Project	<b>IEEE 802.16 Broadband Wireless Access Working Group</b> < <a href="http://ieee802.org/16">http://ieee802.org/16</a> >	
Title	<b>DBTC Protocol</b>	
Date Submitted	<b>2001-02-27</b>	
Source(s)	Ken Stanwood Ensemble Communications 9890 Towne Centre Dr. San Diego, CA 92121	Voice: (858) 404-6559 Fax: (858) 638-7142 <a href="mailto:ken@ensemblecom.com">mailto: ken@ensemblecom.com</a>
Re:	Letter Ballot #3	
Abstract	A description of the use of the DBTC MAC Management messages	
Purpose	Provide text and figures for a comment for Letter Ballot #3.	
Notice	This document has been prepared to assist IEEE 802.16. It is offered as a basis for discussion and is not binding on the contributing individual(s) or organization(s). The material in this document is subject to change in form and content after further study. The contributor(s) reserve(s) the right to add, amend or withdraw material contained herein.

# DBTC Protocol

## Explicit Changes

Figure 1: Transition to a More Robust Burst Type

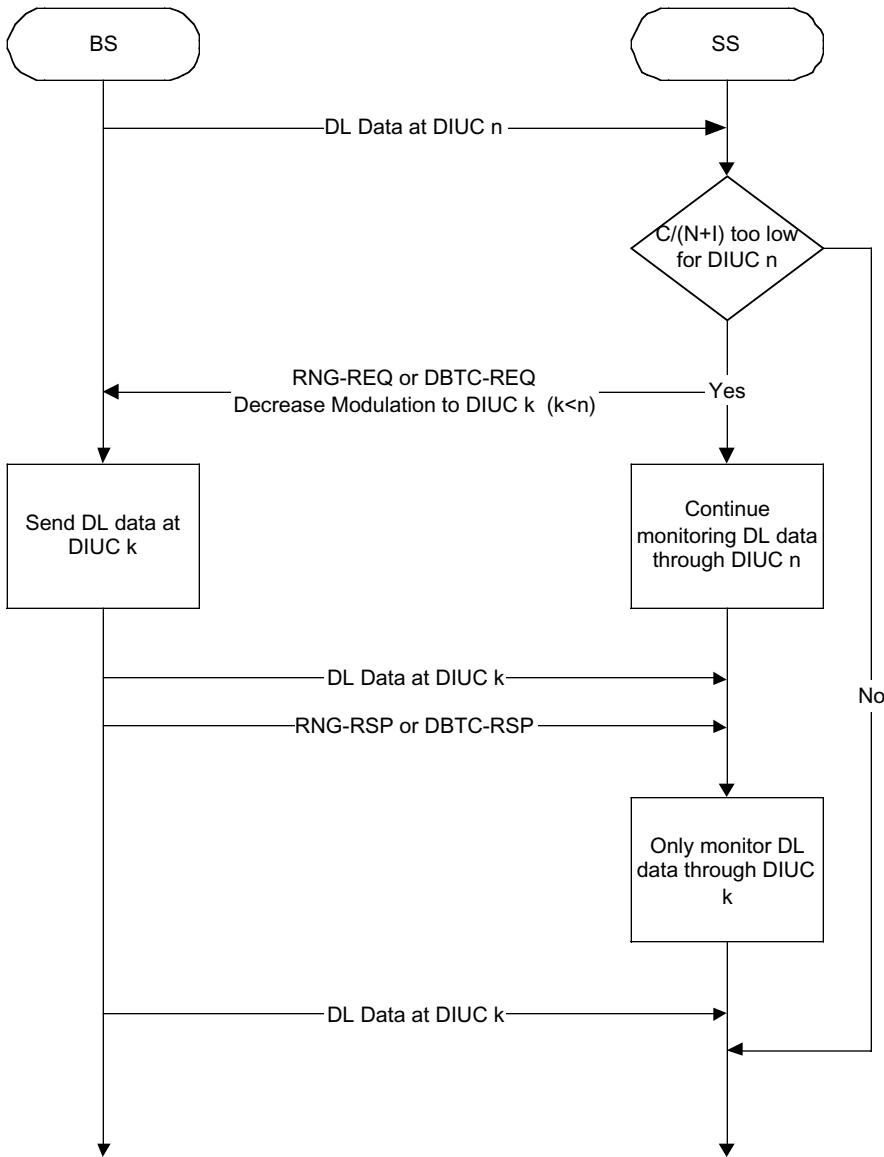
1. On page 142, line 40 – replace “the RNG-REQ message” with “either of three methods”.
2. On page 142, line 41 – replace the last 2 sentences of the paragraph and the following figure (91) with:

“If the SS has a station maintenance interval available it shall send a RNG-REQ message to which the BS responds with a RNG-RSP message. Otherwise, the SS shall send a DBTC-REQ message in an uplink allocation addressed to that SS’s basic connection (regardless of whether the SS is GPC or GPT). The BS responds with a DBTC-RSP message. If neither of these options is available, and the SS requires a more robust burst profile on the downlink, the SS shall send a RNG-REQ message in an initial maintenance interval. In all three methods, the message is sent using the basic CID of the SS. The coordination of message transmit and receipt relative to actual change of modulation is different depending upon whether an SS is transitioning to a more or less robust burst type. Figure 1 shows the case where an SS is transitioning to a more robust type. Figure 2 shows transition to a less robust burst type.
